PARADISE WATERS, DEEBING HEIGHTS PRECINCT A

PRELIMINARY WATERWAY STABILITY ASSESSMENT

RE: PARADISE WATERS STORMWATER DESIGN REQUEST FOR INFORMATION RESPONSE

Figure 1: Precinct A external catchment details

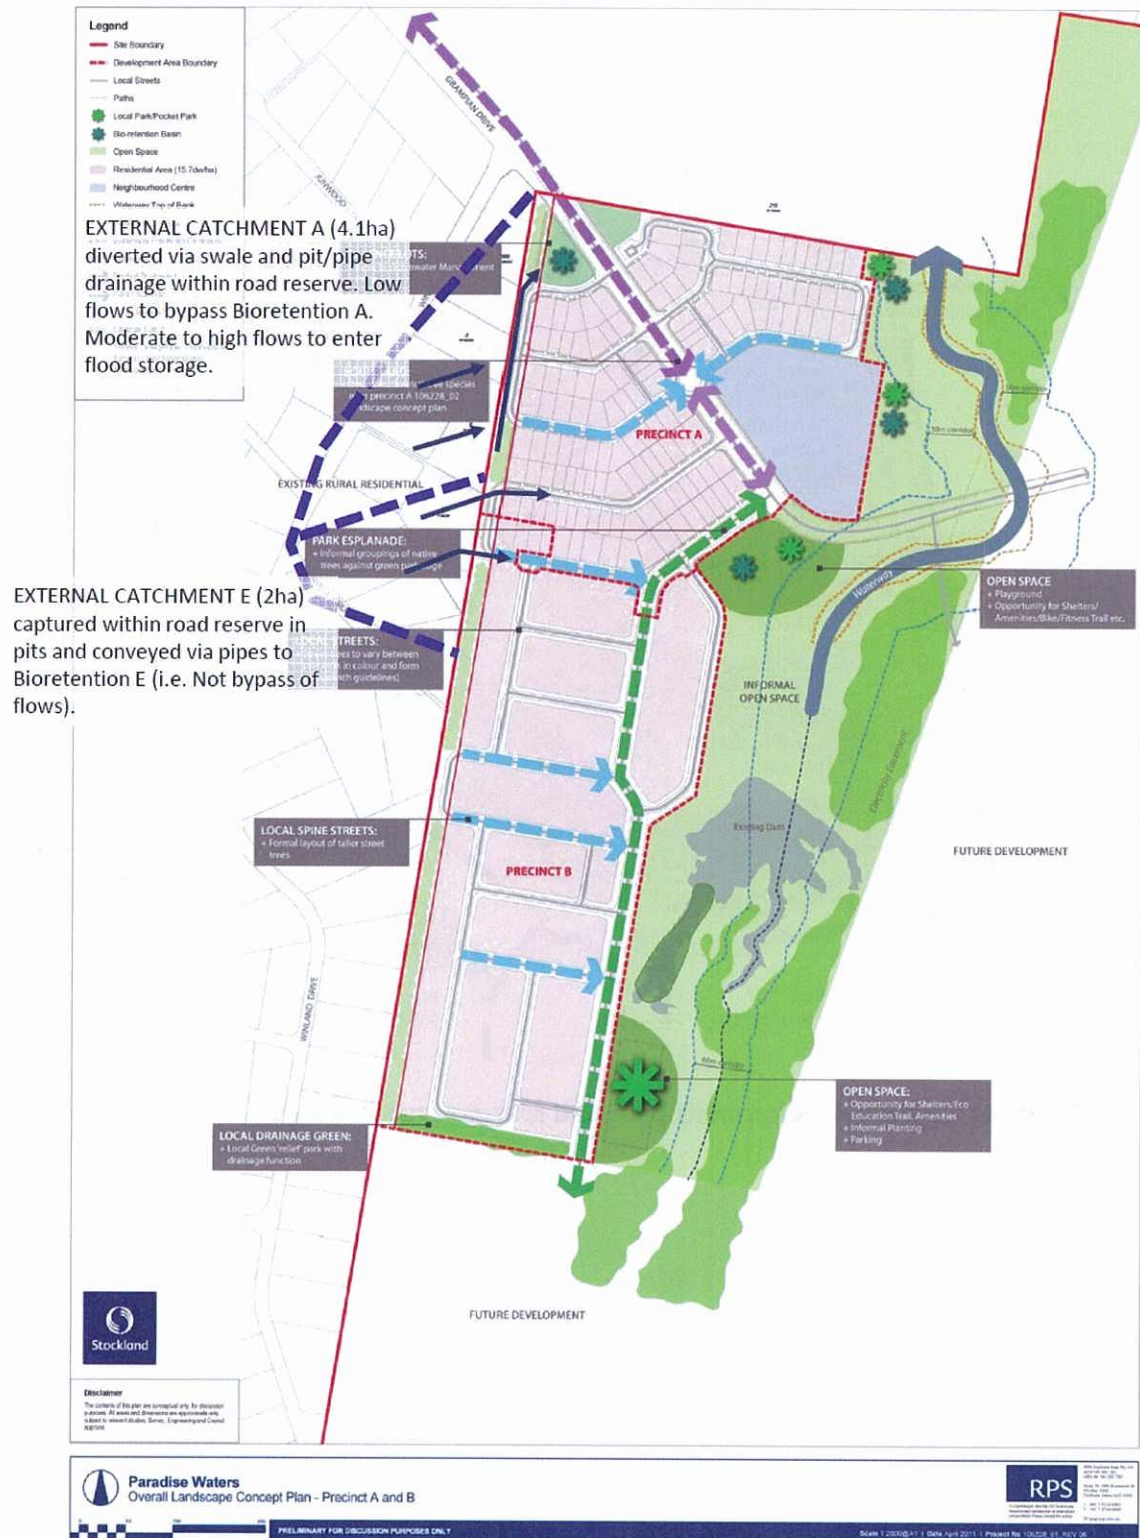
Stormwater Management Plan: Section 5.1.1	It is stated that bioretention basins have been sized for the development only, but flows from external catchments will also enter the basins. While these catchments are described as 'small' they could significantly impact on the basin's performance.	Please provide the total and impervious areas of external catchments, and show their effect on basin performance. Alternatively, demonstrate how external catchments flows can be bypassed around the bioretention basins.
---	--	--

In response to this item, further details of how the external catchment to the west of Precinct A is being dealt with are provided in the following figures:

- Figure 1 illustrates the location and size of the external catchments.
- Figure 2 presents the original stormwater strategy contained in the DesignFlow (2010) Stormwater Quality Management Plan for Precinct A Paradise Waters
- Figure 3 presents the updated stormwater strategy for Precinct A including how the external catchments are considered. Please note the location and size of the stormwater management systems has not changed since the original DesignFlow (2010) SQMP (presented in Figure 2).
- Figure 4 illustrates how 'stormwater quality flows' (<0.5yr ARI) will be diverted around Bioretention Basin A.
- Figure 5 presents the MUSIC model structure and results.
